APPLICATION FOR PERMISSION

A/YL-TYST/1168 UNDER SECTION 16 OF THE TOWN PLANNING ORDINANCE (CAP.131)

(a) Proposed use(s)/development 擬議用途/發展	TEMPORARY EATING PLACE AND OUTSIDE SEATING ACCOMMODATION (OSA) OF RESTAURANT (Please illustrate the details of the proposal on a layout plan) (請用平面圖說明擬議詳情)

Application No. 申請編號	(For Official Use Only) (請勿填寫此欄)
Location/address 位置/地址	LOTS 1355 RP AND 1356 RP (PART) IN D.D. 121, TONG YAN SAN TSUEN, YUEN LONG, NEW TERRITORIES. 新界元朗唐人新村丈量約份第121約地段 第1355號餘地及第1356號餘地(部分)
Site area 地盤面積	2175 sq. m 平方米 □ About 約 (includes Government land of 包括政府土地 sq. m 平方米 □ About 約)
Plan 圖則	APPROVED TONG YAN SAN TSUEN OUTLINE ZONING PLAN (02P) NO. S/YL-TYST(14)
Zoning 地帶	RESIDENTIAL (Group B)1
Type of Application 申請類別	<input checked="" type="checkbox"/> Temporary Use/Development in Rural Areas for a Period of 位於鄉郊地區的臨時用途/發展為期 <input checked="" type="checkbox"/> Year(s) 年 3 <input type="checkbox"/> Month(s) 月 <input type="checkbox"/> Renewal of Planning Approval for Temporary Use/Development in Rural Areas for a Period of 位於鄉郊地區臨時用途/發展的規劃許可續期為期 <input type="checkbox"/> Year(s) 年 <input type="checkbox"/> Month(s) 月
Applied use/ development 申請用途/發展	TEMPORARY EATING P

RUN-IN/OUT PROPOSAL APPLICATION SITE

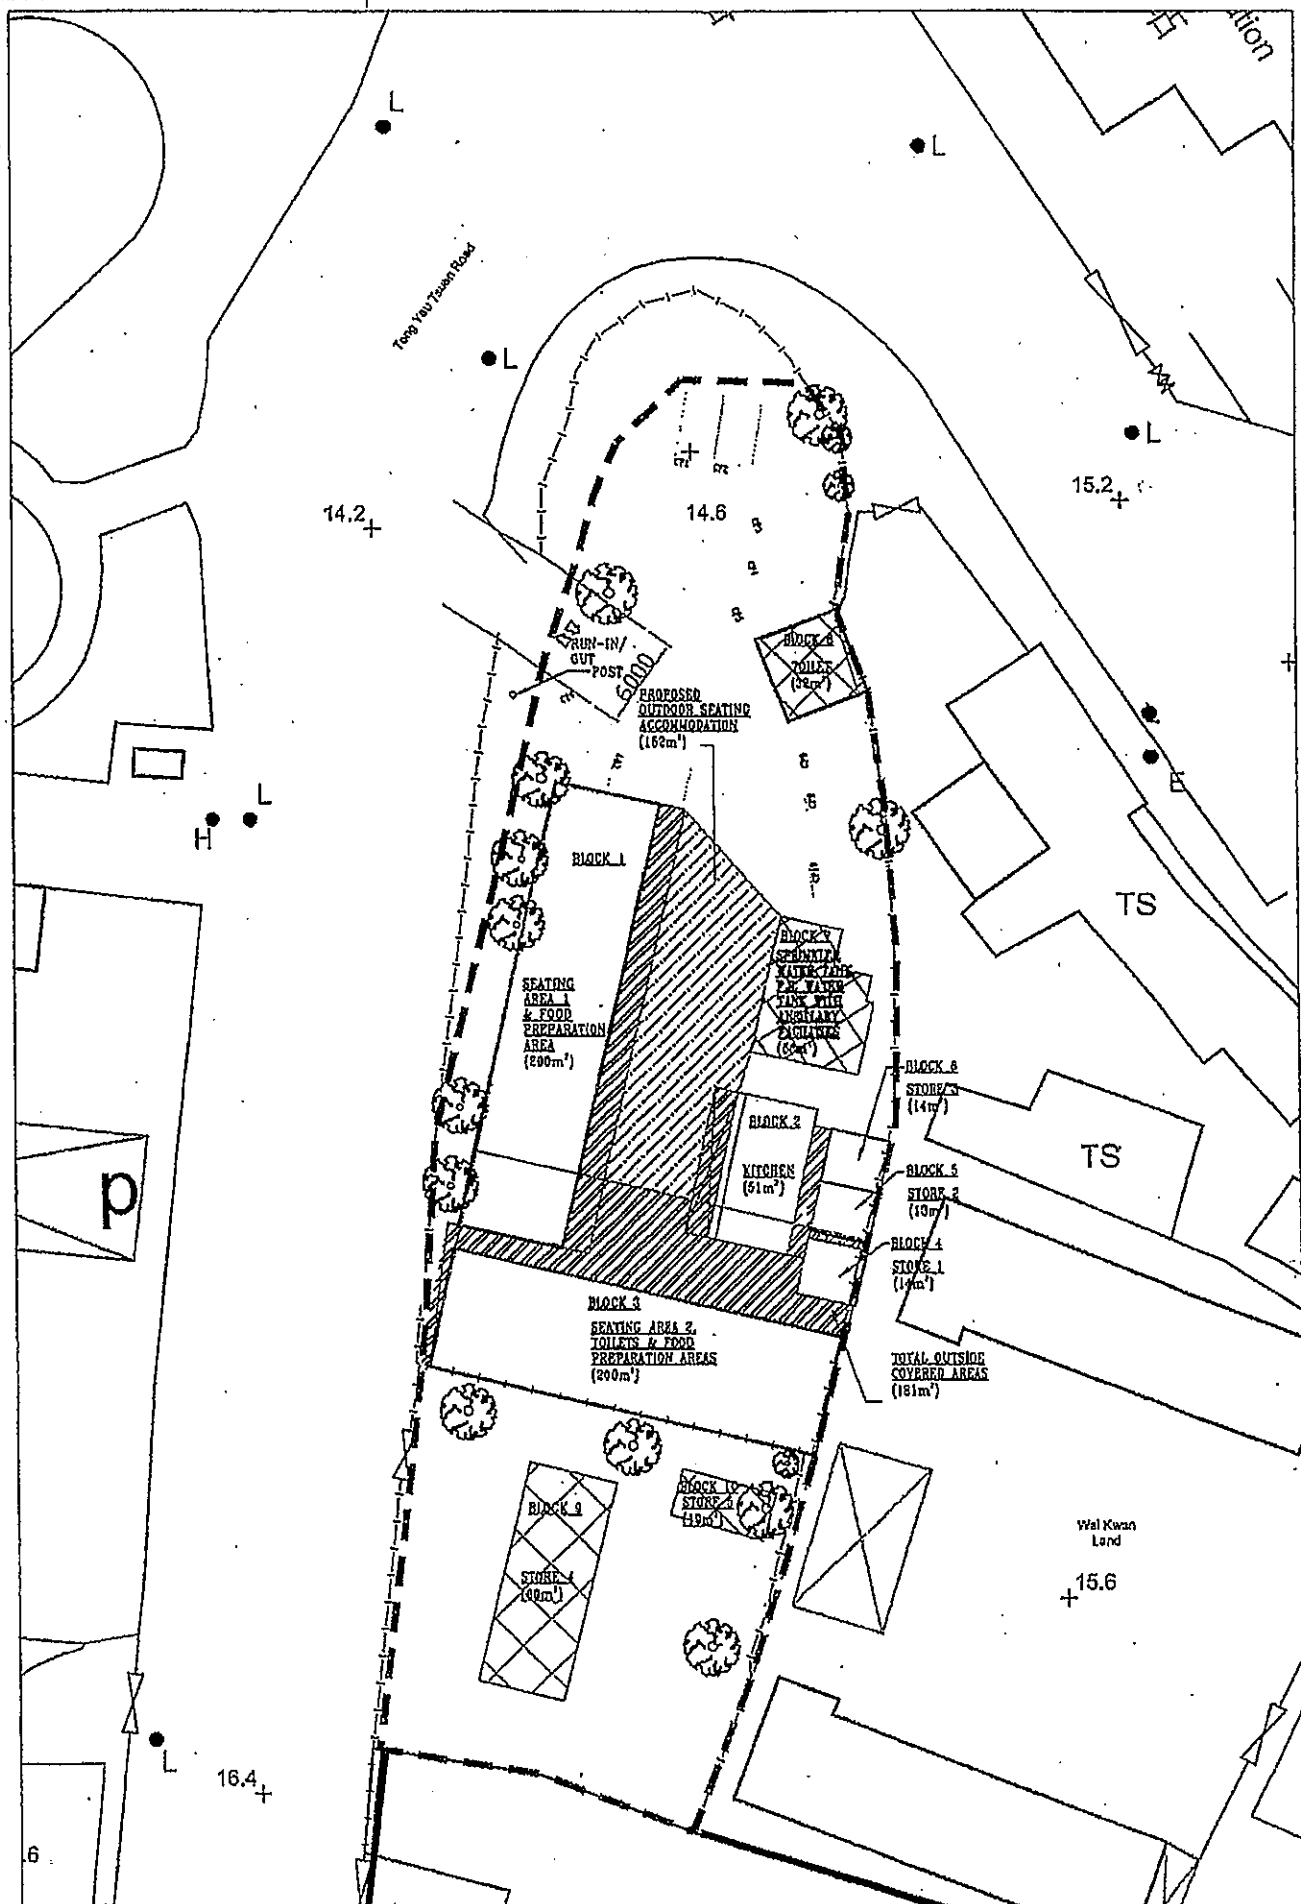
- no adverse comment on the application; and
- if the proposed access on Tong Yan San Tsuen Road is approved by the Transport Department, the applicant should ensure a run-in/out is constructed in accordance with the latest version of his department's Standard Drawing No. H1113 and H1114, or H5133, H5134 and H5135, whichever set is appropriate to match with the existing adjacent pavement.

Estimated Trip Generation and Attraction Report

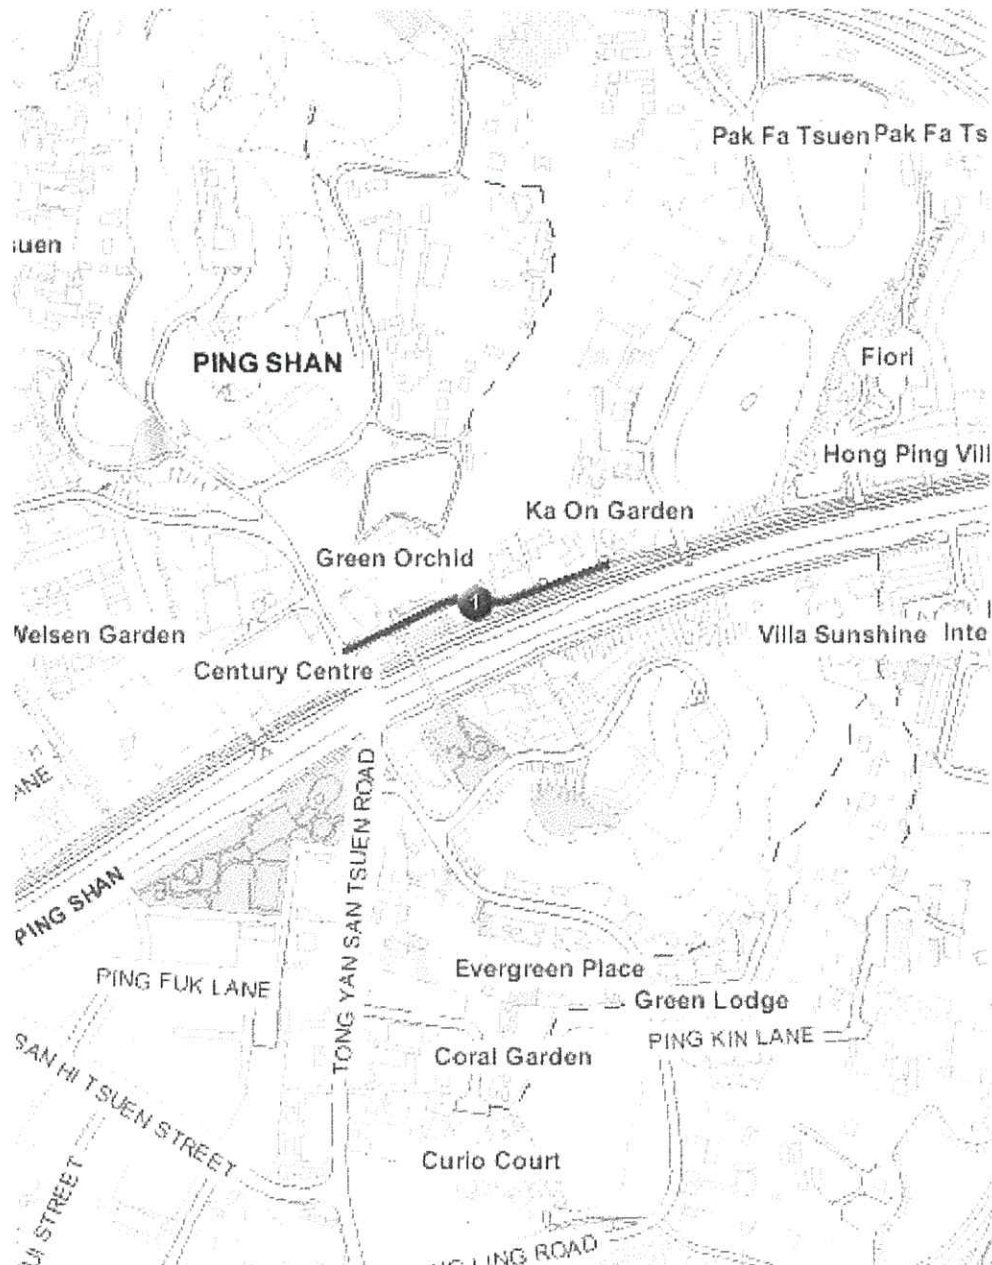
Please see below for comment from Mr. Dicky WONG of Transport Department on the captioned application:

As talked with Mr. Wong today, regarding the estimated trip generation in App. I X, the assumption had revised for 13% of the customer will come by private cars. Here attached the revised App. I X for your handling.

Another assumption is that each car will carry 4 people. Therefore, 15 private cars will come to this restaurant. On average, one car will arrive at every 8 minutes. This restaurant can provide 10 numbers of parking spaces. Therefore, 5 numbers of private car cannot park in the restaurant. Our staff will park to a nearby hourly car park in Ping Hing Lane. It is only 5 minutes-time walking distance from the restaurant via a foot bridge at Castle Peak Road (Plan I). This car park has more than 200 numbers of parking spaces (Photo 1). We will post a map at the entrance of the restaurant that clearly shows the route from the restaurant to the carpark and employ sufficient staff to help the customers to park their cars at this car park. We will ensure no car will queue up on the Road, once the customers drop off inside the restaurant, we will arrange sufficient staff to drive their car immediately to the car park at Ping Hing Lane. The above-mentioned proposal was based on our estimation that three numbers of staff would be enough to handle the parking arrangement. It is not a difficult requirement to achieve.
